Access Compliance Report

Public Rights-of-Way

Intersection ID: 43693	Main Street: WEDDINGTON_RD	Cross Street: PORTSTEWART_LN	Location: SW
ADA ID: FAA8032AD1C4	Ramp Type: Perp	Initial Pass/Fail: Fail	Overall Compliance: No
Severity Score: 21.25			
Codes/Mitigation Info/Possible Solution		Field Measurements/Component Compliance

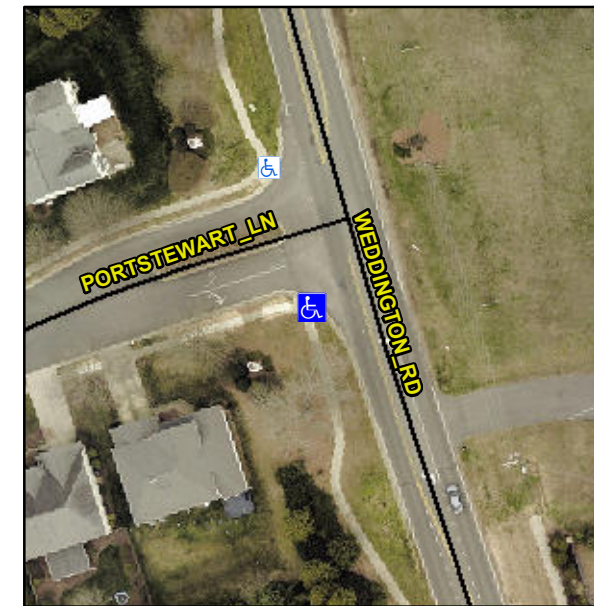
Not Found, R304.5.1, R304.2.2

Compliance	Description	Data	Compliance	Description	Data
N/A	Ramp Length (in)	48.0	No	Ramp Slope (%)	10.6
No	Ramp Width (in)	42.0	Yes	Ramp XSlope (%)	1.9
N/A	Flare Type LT	N/A	N/A	Flare Type RT	N/A
N/A	Flare Slope LT (%)	N/A	N/A	Flare Slope RT (%)	N/A
N/A	Flare Traversable LT?	N/A	N/A	Flare Traversable RT?	N/A
N/A	Landing Length (in)	N/A	N/A	DWS Provided?	N/A
N/A	Landing Width (in)	N/A	N/A	DWS Contrast?	N/A
N/A	Landing Slope (%)	N/A	N/A	DWS Length (in)	N/A
N/A	Landing X Slope (%)	N/A	N/A	DWS Full Width?	N/A
N/A	Landing Curb? (Y/N)	N/A	N/A	DWS Offset (in)	N/A
N/A	Shared Landing?	N/A			
N/A	Gutter Ponding?	N/A	N/A	Gutter Slope (%)	N/A
N/A	Gutter Lip Ht (in)	N/A	N/A	Gutter X Slope (%)	N/A
N/A	Painted X Walk1?	No	N/A	Painted X Walk2?	N/A
	X Walk 1 Direction	To N		X Walk 2 Direction	N/A
N/A	X Walk 1 Width (in)	N/A	N/A	X Walk 2 Width (in)	N/A
	X Walk 1 Slope (%)	0.3		X Walk 2 Slope (%)	N/A
	X Walk 1 X Slope (%)	0.5		X Walk 2 X Slope (%)	N/A

Remove & Replace Entire Ramp.
